B-557617

BASIC SWITCH SECTIONS

WESTERN ELECTRIC COMPANY, INC
ENGINEER OF MANUFACTURE
BELL TELEPHONE LABORATORIES
INCORPORATED

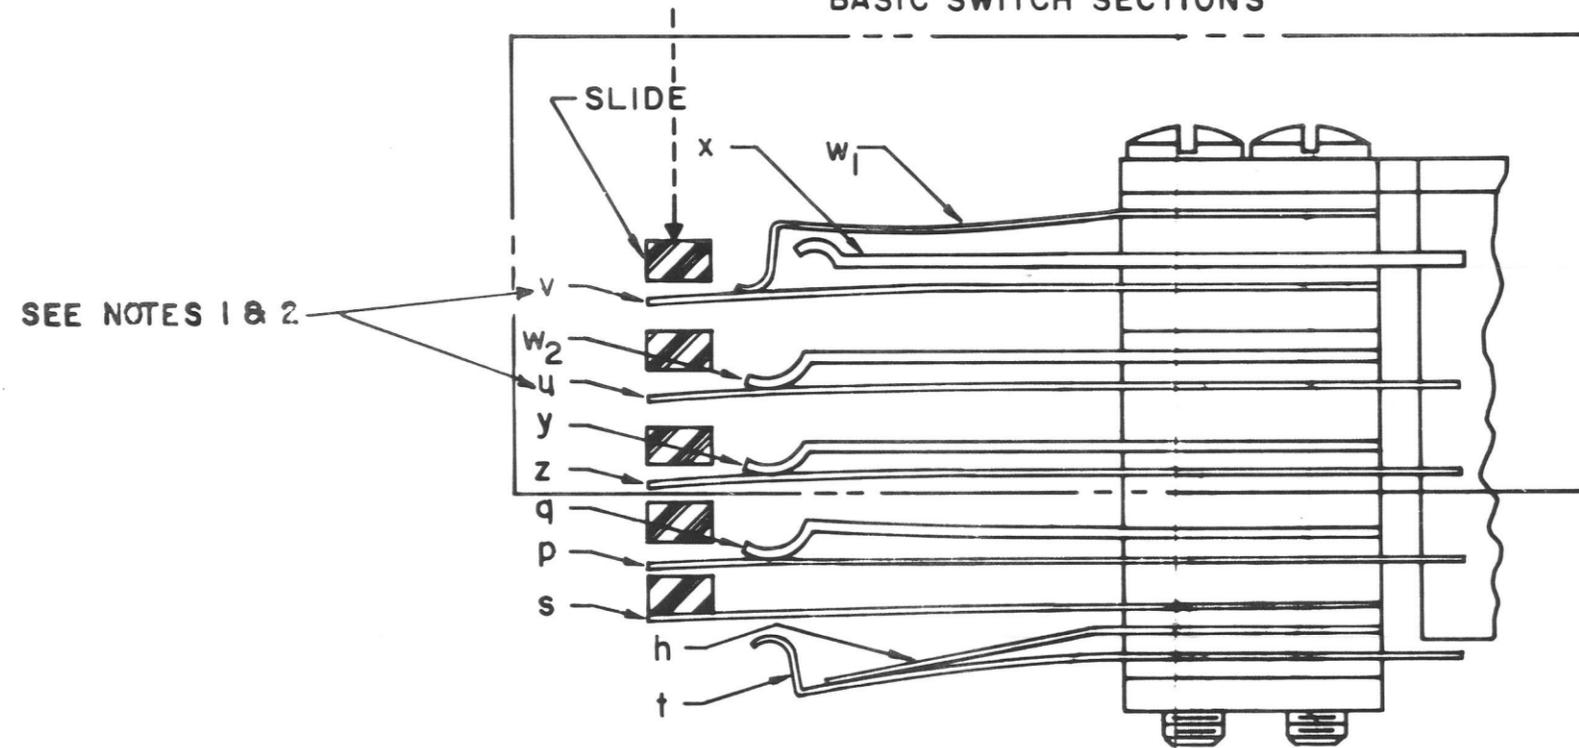
CONTACT DESIGNATIONS U & V
WERE SHOWN REVERSED. NOTES
1 & 2 ADDED. 25L, 25M, 27A, 35B,
& 35M CODES ADDED IN TITLE.

REMOVED: REFERENCE TO
REPAIR AND 27A DIAL IN TITLE
AND 27A IN NOTE 1
ADDED: NOTES 3 & 4

1. THE U & V CONTACTS ON 22C DIAL ARE REVERSED FROM THOSE SHOWN.
2. ON SOME 25F & 25G DIALS MANUFACTURED PRIOR TO MARCH 1964, THE U & V CONTACTS ARE REVERSED FROM THOSE SHOWN.
3. DOES NOT APPLY TO 25F, AND 25G DIALS MANUFACTURED AFTER 6-1-66.
4. ON 22B, 25A, 25B, 25E, & 25H DIALS MANUFACTURED PRIOR TO MARCH 1964 WHICH HAVE NOT BEEN MODIFIED IN ACCORDANCE WITH BSRS-451.917, THE U & V CONTACTS ARE REVERSED FROM THOSE SHOWN.
